1984 - 1985 Corvette: Service Bulletin: Improperly Installed Reverse Idler Shaft Roll Pin

Subject: IMPROPERLY INSTALLED REVERSE IDLER SHAFT ROLL
PIN

Model and Year: 1984-1985 CORVETTE

Bulletin Number: 85-31 - (01/09/1985)

FIG. 1 REVER

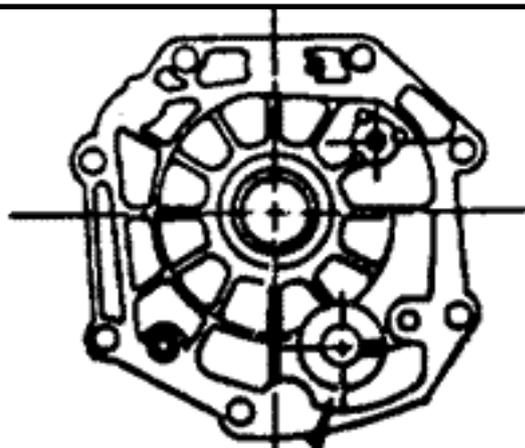
Damage to the manual transmission may occur if the roll pin securing the reverse gear idler shaft to adapter plate (Figure 1) is not fully seated to prevent the shaft from spinning and/or backing out. To insure assembly operation results in the shaft securely locked in place, the roll pin has been lengthened from 0.50" to 0.75". When servicing transmissions with the shorter roll pin (0.50"), discard the roll pin and replace with longer roll pin (0.75") maximum.

FIG. 2 PIN INSTALLATION

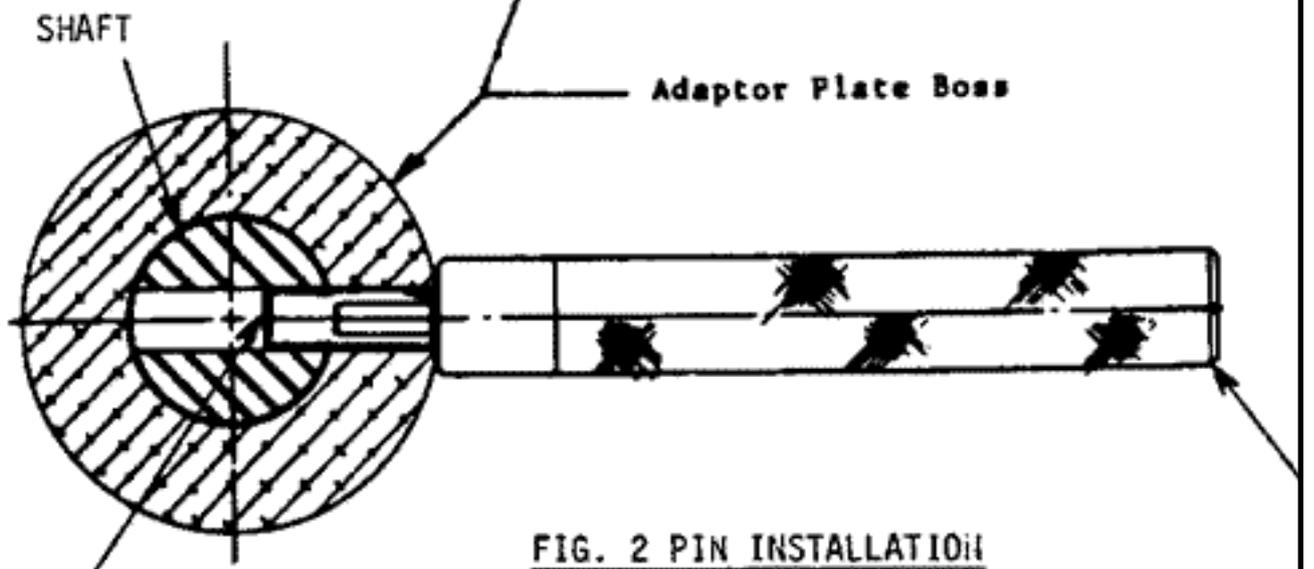
2. Insert 0.75" roll pin into plate boss hole and, with small punch tool, carefully drive roll pin flush with plate boss (Figure 2).

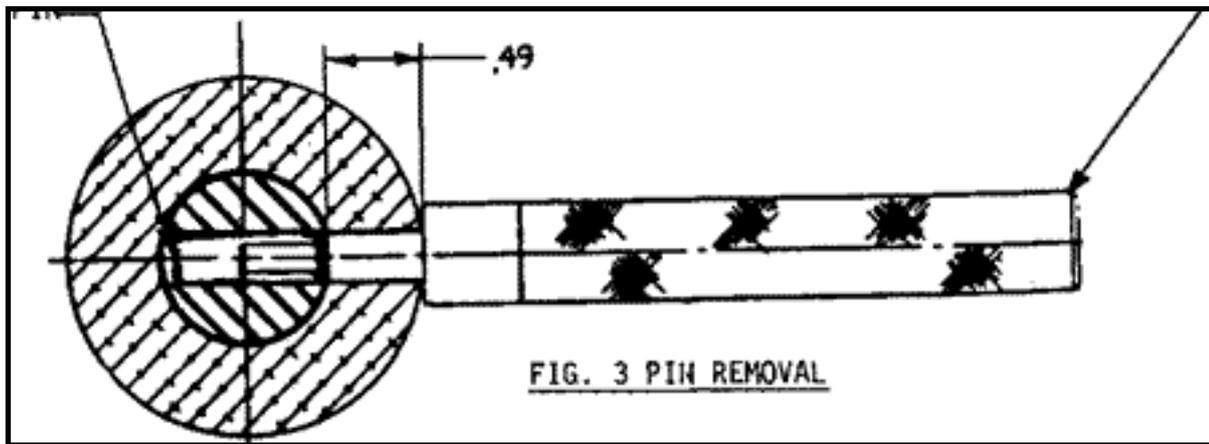
1. Insert small punch tool into plate boss hole and carefully drive roll pin into reverse idler shaft (Figure 3).

Driving roll pin too hard may cause to jam and result in shaft binding to adapter plate.
